# **The storage of liquid high level waste at BNFL, Sellafield**

Addendum to February 2000 Report

Published by the Health & Safety Executive,  
August 2001.

Fig 1. Total HAL Stocks Limiting Envelope - Proposal at 31 July 2000

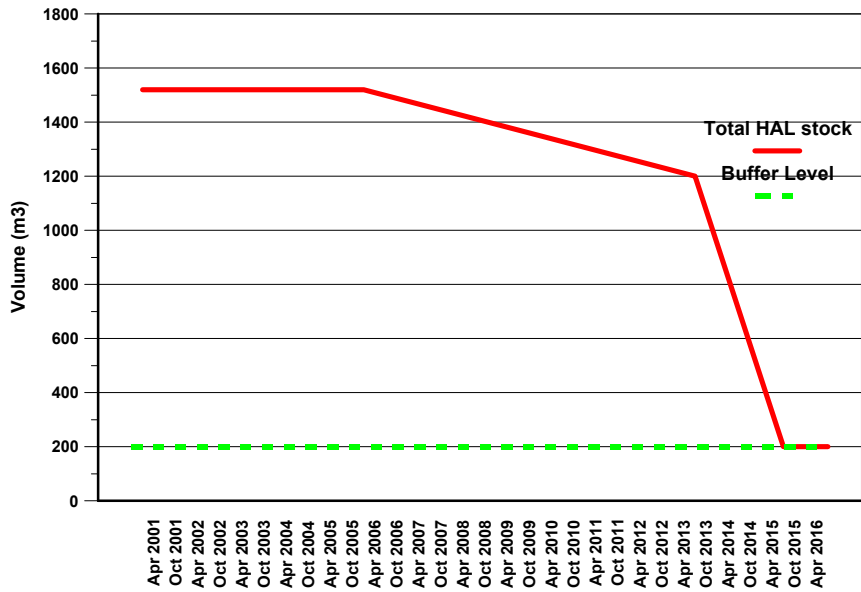
114. Figure 1 shows the BNFL proposed limits for the reduction of HAL stocks as submitted at 31 July 2000. Beneath this limiting curve, stocks build up initially whilst vitrification capacity is built up and as business continues in accordance with the business plan for the baseload of 7000te (ending around 2006/7). Post-baseload business has a number of uncertainties after the currently contracted THORP business is completed around 2010.

119. NII assessment of the proposals submitted at 31 July 2000 and depicted in Figure 1 revealed several areas for improvement:

a) They did not reflect a realistic starting datum for stocks measured in volume terms because, during 2000, it had been necessary to accept significant quantities of HAL at reduced concentrations. This resulted from operational problems with in-tank evaporation and arisings of additional inactive wash liquors due to problems of solids in the evaporators. At January 2001 the realistic start point would therefore have to be higher than shown in the July proposals in terms of volume even though neither activity content nor heat loading had been increased. Further plant simulation modelling runs were therefore agreed which reflected initial conditions projected to pertain on plant at January 2001.

c) The 31 July proposals were defined in terms of total volume only and compliance would be fundamentally dependent on achievement of the vitrification plant throughputs. Concerns were that if WVP performance fell short, THORP could continue to feed forward oxide derived liquors to the HALES plant in preference to a feed of Magnox liquors from the Magnox reprocessing plant. (This would be even more likely if problems were experienced on the B205 Magnox reprocessing plant). This would

Fig 2. Total HAL Stocks Limiting Envelope & Oxide/Blended HAL Tracking Envelope

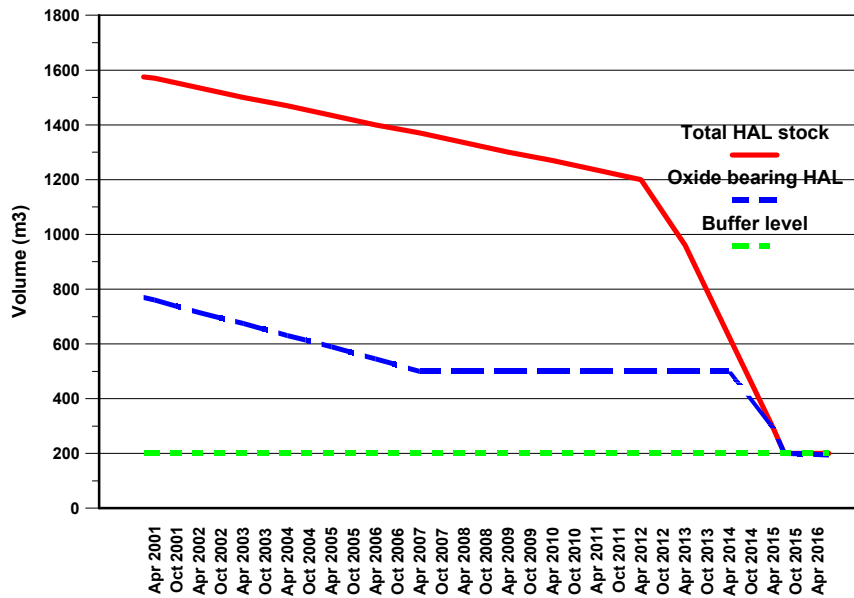
122. Allowing for an operational margin, a control level of 500m<sup>3</sup> was therefore agreed, with a linear reduction to this level from current stocks essentially over the baseload period. This control is shown diagrammatically by the lower line in Figure 2.
